Service Letter No. SL-AG-77 30 January, 1976

## CARBURETOR AIR INLET SCOOP ASSEMBLY REPLACEMENT

**MODELS AFFECTED:** MODEL S-2R, S/N 5000 thru 5082.

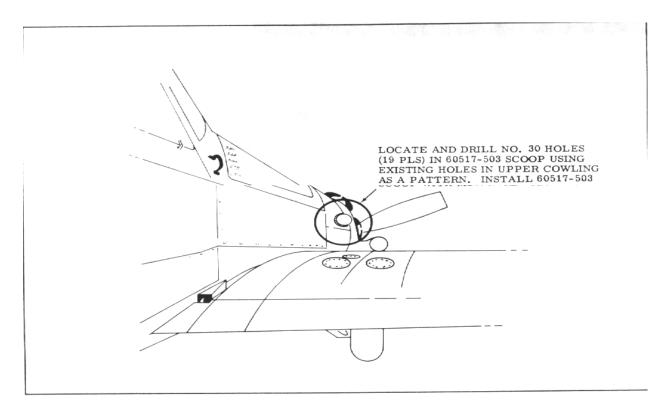
**REASON FOR PUBLICATION:** Provide an improved carburetor air inlet scoop.

- 1. Inspect existing carburetor air inlet scoop, located on right side if upper engine cowling, to assure scoop installed is manufactured from aluminum material.
- 2. If scoop is manufactured from aluminum material, proceed to RECORD COMPLIANCE.

- 3. If scoop is manufactured from fiberglass material, proceed to step 4.
- 4. Remove upper engine cowling.
- 5. Remove and discard existing carburetor air inlet scoop from upper engine cowling.
- 6. Locate, drill and install 60517-503 scoop picking up existing holes in upper engine cowling (see Figure 1.).
- 7. Reinstall upper engine cowling.
